DELETED**Second Revision No. 1195-NFPA 13-2023 [Global Comment]**

Second Revision No. 1169-NFPA 13-2023 [Detail]

Figure A.3.3.21 Example of Blocking at Intersection of Purlins and Girders.

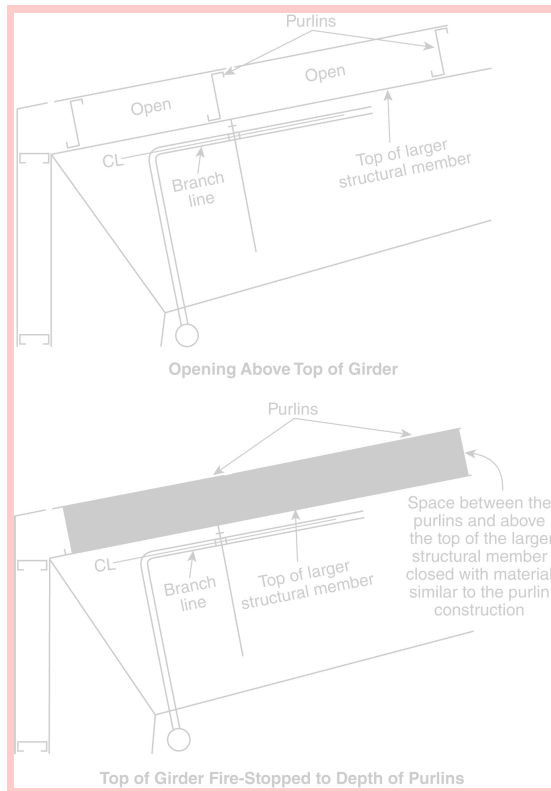
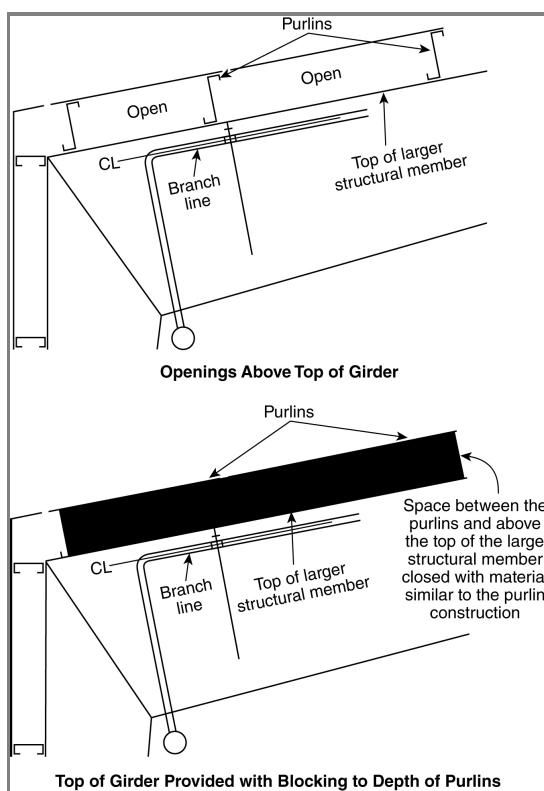
Blocking is required in several instances within this standard to restrict the horizontal flow of heat within channels created by obstructed construction, which is referred to as *channeling*. The blocking helps reduce the channeling effect created by obstructed construction so that the heat from a fire can fill a specified channel volume before eventually flowing horizontally under the structural members and activating ceiling sprinklers in a timely fashion. See Figure A.3.3.21 for an example of blocking a purlin at the intersection of a girder. The material utilized for blocking does not have to have a fire resistive rating, rather it only requires noncombustible materials for the blocking when the structural elements are noncombustible. While it is ideal to have blocking that is tight to the ceiling, the intent of this section is to not require the small gaps created by a corrugated roof decking to be filled. (AUT-SSD)

Figure A.25.5.1.2.3 Example of Horizontal and Vertical In-Rack Sprinkler Installation When Only a Portion of an Open Rack, Protected by CMSA Ceiling-Level Sprinklers, is Obstructed by Solid Shelving.

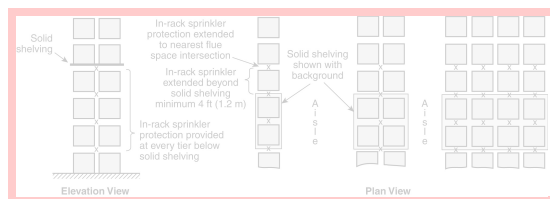
See Figure A.25.5.1.2.3 for an example showing the installation of in-rack sprinklers within racks having solid shelves that obstruct only a portion of an open rack protected by CMSA ceiling-level sprinklers.

Where racks with solid shelves obstruct only a portion of an open rack, in-rack sprinklers shall be installed in accordance with 25.5.1.3.1 – (See Figure A.25.5.1.2.3.)

Figure A.25.6.1.2.3 Example of Horizontal and Vertical In-Rack Sprinkler Installation When Only a Portion of an Open Rack, Protected by ESFR Ceiling-Level Sprinklers, is Obstructed by Solid Shelving.

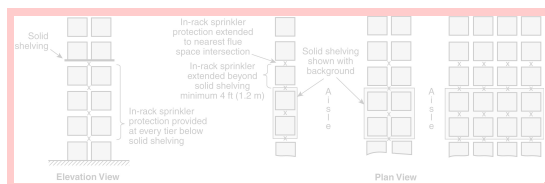
See Figure A.25.6.1.2.3 for an example showing the installation of in-rack sprinklers within racks having solid shelves that obstruct only a portion of an open rack protected by ESFR ceiling-level sprinklers.

Where racks with solid shelves obstruct only a portion of an open rack, in-rack sprinklers shall be installed in accordance with 25.6.1.3.1 - (See Figure A.25.6.1.2.3.)

Figure 25.7.2.3.1(d) Option 2b — In-Rack Sprinkler Arrangements for Class I through Class IV and Cartoned Group A Plastic Commodities, Maximum 40 ft (12.2 m) Vertical Increments.

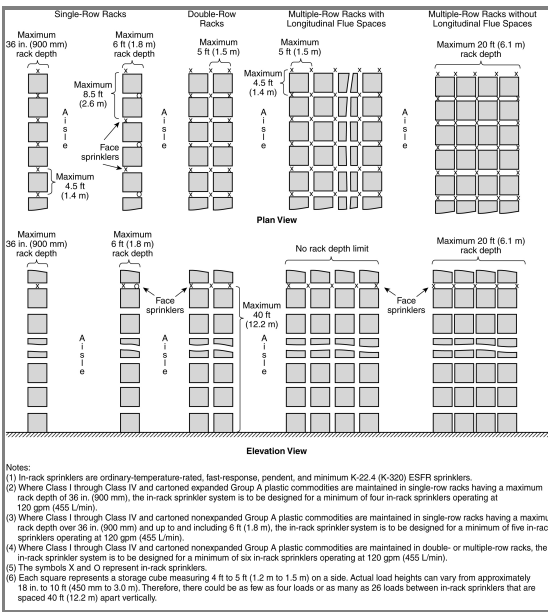
For editorial use. See Figure 25.7.2.3.1(d) for location to add "maximum 10 ft (3.0 m)" dimension.

Committee Statement: To enhance usability and readability, options correlating to Table 25.7.2.3.1 have been added in the Figure names.

Figure A.28.5.1.2(b) Hydraulic Calculation Example (Plan View and Elevation View).

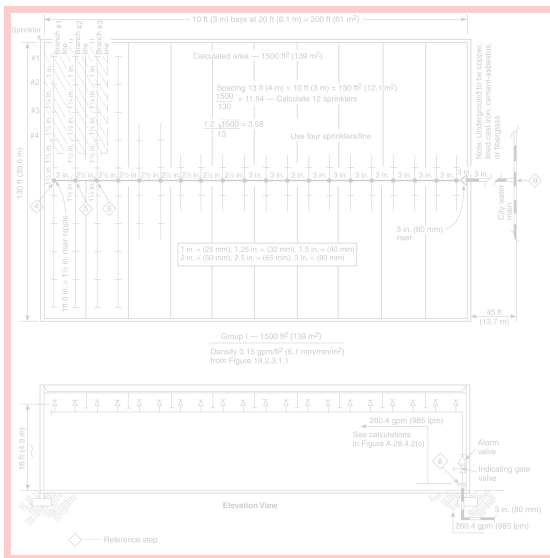
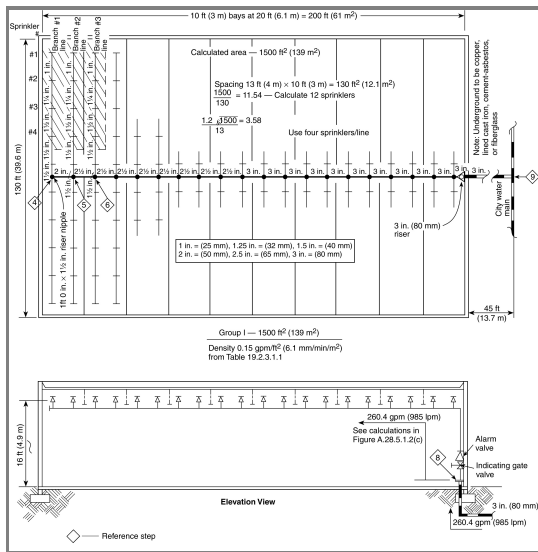
Review section Figure A.28.3.5.1.2(b) as Figure 19.2.3.1.1 has been deleted as part of an FR. References to this figure will need to be cleaned up. Suggest changing "or Figure 19.2.3.1.1" to "table 19.2.3.1.1."

Committee Statement: A list is not included in 28.5.1.2, therefore the word "following" has been removed. Figure 19.2.3.1.1 was deleted during first revision. Figure 19.2.3.1.1 has been changed to Table 19.2.3.1.1. Note that the CC note incorrectly referenced Figure A.28.3.5.1.2(b). The correct reference is A.28.5.1.2(B).

Figure A.28.1(a) Typical Preliminary Plan.

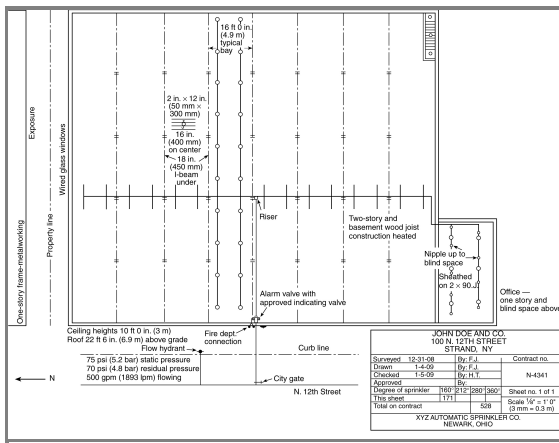
Preliminary plans should be submitted for review to the authority having jurisdiction prior to the development of working plans [see Figure A.28.1(a)]. The preliminary plans can be part of the construction documents submitted in order to obtain a building permit. However, working drawings in accordance with Section 28.1 should be submitted and approved prior to the installation of system equipment. Preliminary plans should include as much information as is required to provide a clear representation of the hazard to be protected, the system design concept, the proposed water supply configuration, and the building construction information pertinent to the system layout and detailing.
